Department of Transportation

MEMORANDUM

SUBJECT: ZC Case No. 26-07 – Bridge District Parcel 7

Figure 1 | Site Plan

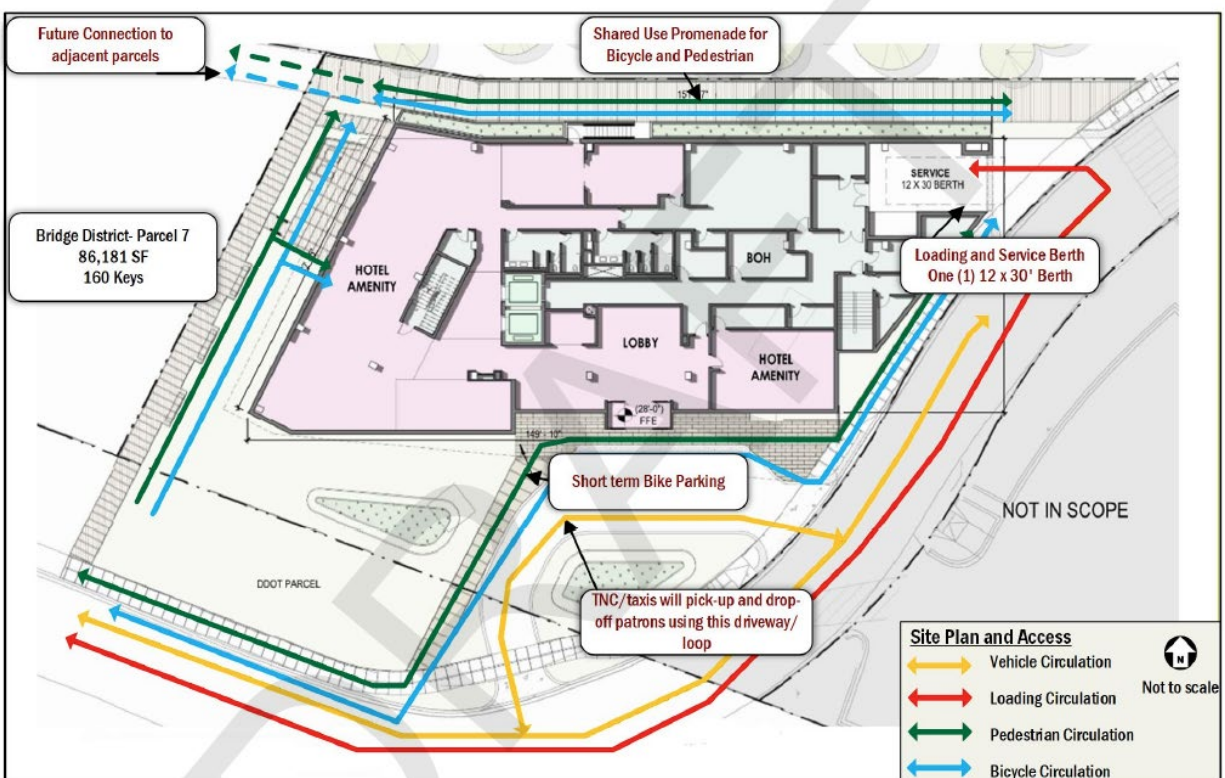
The main entrance to the hotel will face Howard Road, and pedestrians will be able to access the site from both Howard Road and the WMATA access drive. A one-way driveway will provide vehicular access to the main entrance for pick-up and drop-off. A new curb cut is proposed to serve the outlet of this driveway into the small portion of the WMATA drive that is within the Howard Road right-of-way. Figure 1 below shows the site layout of the proposed project.

While the preliminary public space plans, shown above in Figure 1, are generally consistent with DDOT standards, there are several considerations that need to be reviewed in greater detail during the public space permitting process:

- Work with PSD to establish a public access easement for the portions of sidewalk on private property;
- Submit a detailed curbside management plan with proposed signage for review and approval by DDOT Curbside Management Division (CMD). If CMD requires multi-space meters for the frontage, they will be at the Applicant’s expense; and
- Provide a plan showing the detailed design of the long-term bike storage room so PSD can confirm it meets the requirements in Title 11 of *DCMR*, Subtitle C § 800, Title 18 of *DCMR*, § 1214, and DDOT *Bike Parking Guide* best practices, including larger cargo/tandem spaces.

Figure 5 | Existing Pedestrian Network

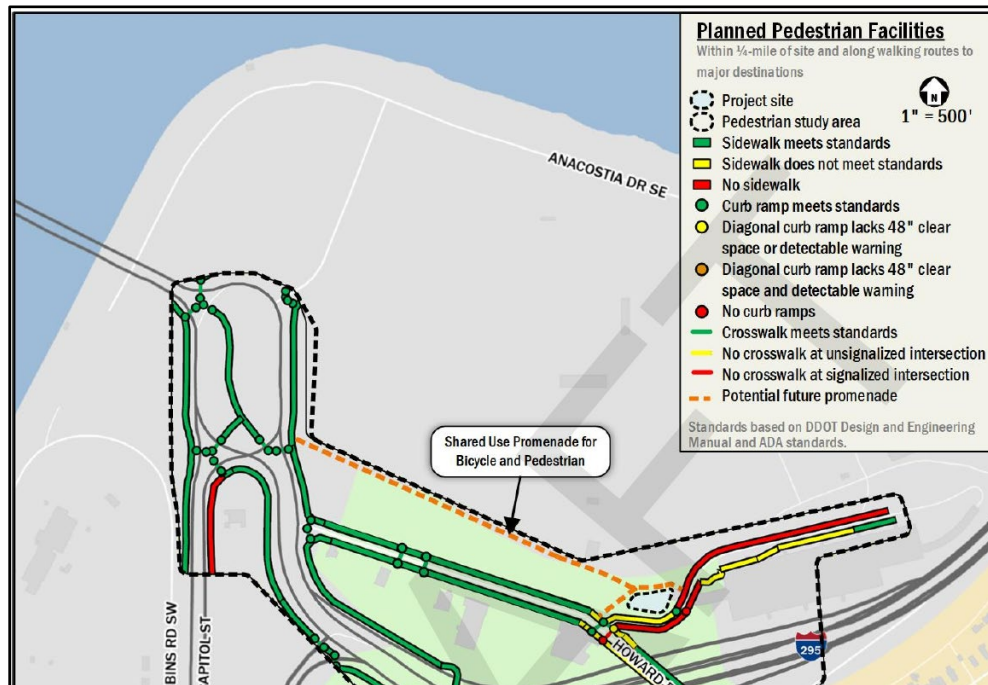
The Transportation Statement's inventory of existing and proposed pedestrian infrastructure, as shown in Figure 4 below, demonstrates that most sidewalks in the immediate vicinity of the site are currently constructed with appropriate widths and include accessible curb ramps. While there are several missing or substandard facilities in the broader area, the existing pedestrian network between the site and the rest of the Bridge District and the Metro Rail station are adequate.

Figure 7 | Proposed Curbside Designations

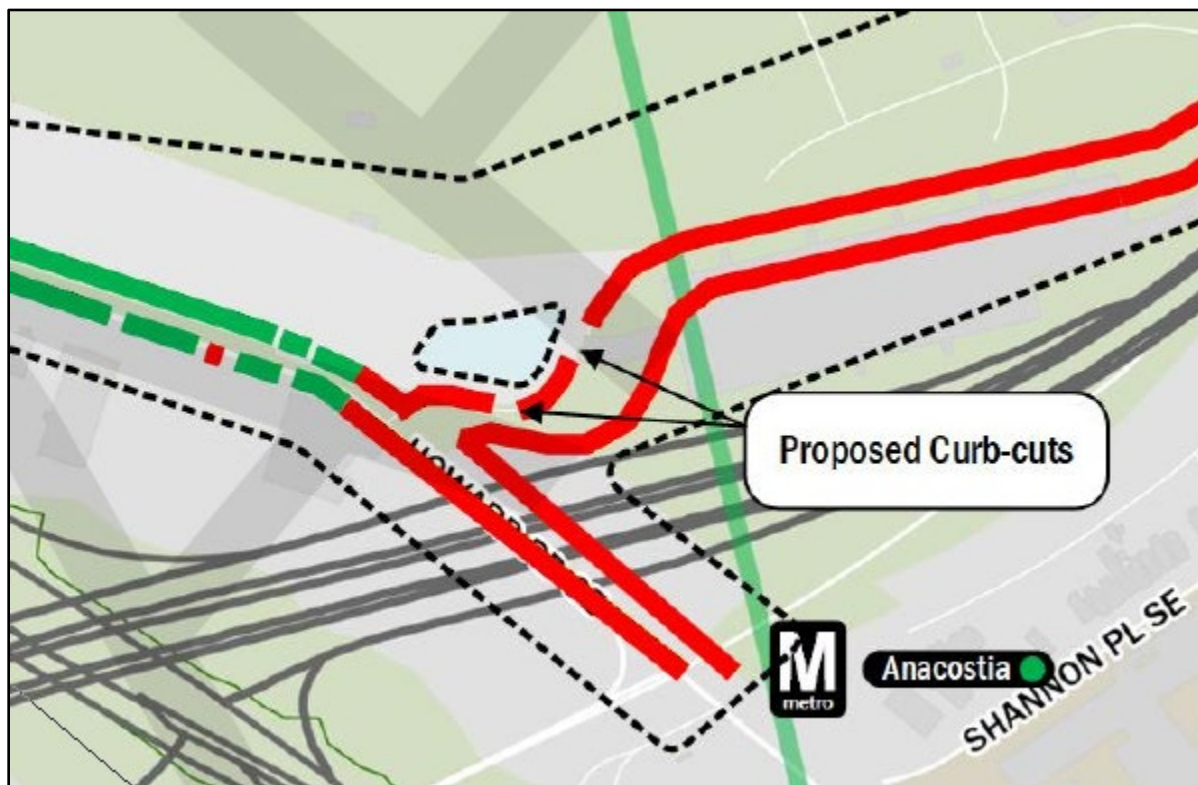
When a property redevelops, it is DDOT policy to reevaluate the existing curbside restrictions around the site frontages to ensure they align with the new land use(s) on the property and surrounding neighborhood context. Parking is currently not permitted along the site's Howard Road and WMATA access road frontages, and the Applicant does not propose any curbside management changes outside the two (2) new curb cuts.

DDOT is generally supportive of this concept, however, a detailed curbside and signage plan must be submitted during public space permitting for review and approval by DDOT's Curbside Management Division (CMD). At that time, the plan may be refined by CMD, and the exact signage placards will be determined. If multi-space meters are required by CMD, they will be at the Applicant's expense.
